STAFF REPORT

PLANNING & ZONING COMMISSION

Wednesday, May 10, 2017

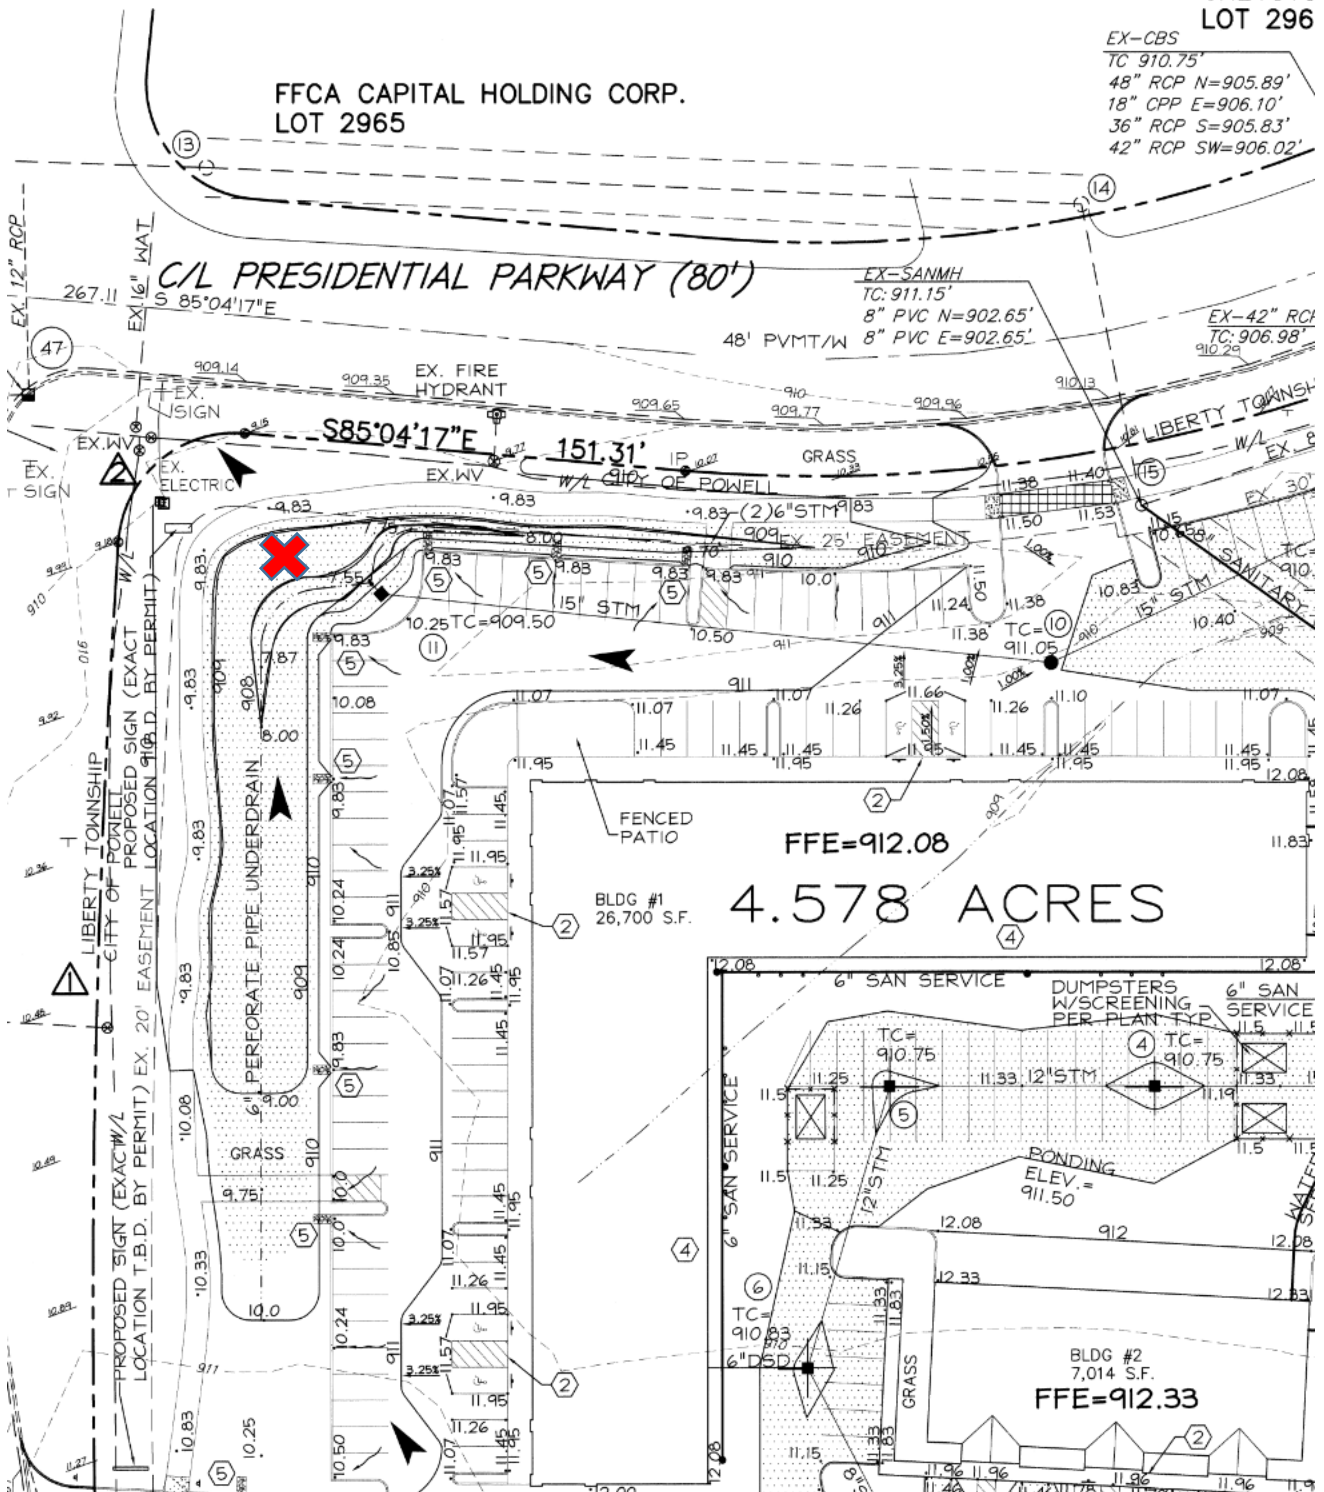
The applicant has indicated that he would rather do this one sign than to split this sign up into another sign that could be placed on the Presidential Parkway side entrance. He is trying to get some visibility on Sawmill Parkway for the tenants that are on the Presidential Parkway side. The tenants on the Sawmill Parkway side do not need to utilize this joint sign as their main building sign faces Sawmill Parkway. Staff suggests that the proposed sign be re-located from where the existing sign is located (which is the proposed location) to an area back behind the bike path in order to become more jointed with the shopping center and because the sign is so much larger than otherwise required, can be more heavily landscaped. Although there is a drainage swale back there, there should be enough room to place this sign. See image on the next page:

Staff recommends approval of this proposed sign as adding a third monument joint identification sign would be the only other option and would not address solving the problem for tenants having visibility from this sign on Sawmill Parkway. The proposed sign with the change in color will differentiate itself from the other shopping center sign and be farther back as Staff has proposed. The City Engineer also agrees that the proposed sign should be setback even further. The following conditions should be added to any approval:
